PRODUCT CHANGE NOTIFICATION

Subject: PCN 115 b - Change to the flange of IP-2X6 modules

Changes:

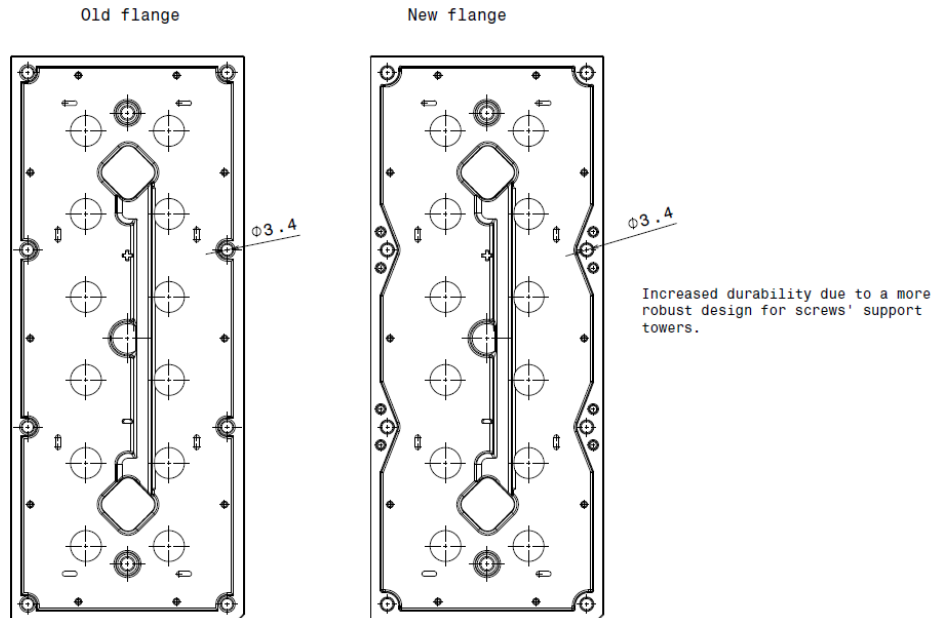
Description: As part of our continuous improvement process regarding the quality of our products LEDiL has changed the mechanical design of the flange on some of our STRADA-IP-2X6 and HB-IP-2X6 lenses. Changes improve durability of modules around screw towers and don't have other mechanical or any optical influences on the performance or use of the products.
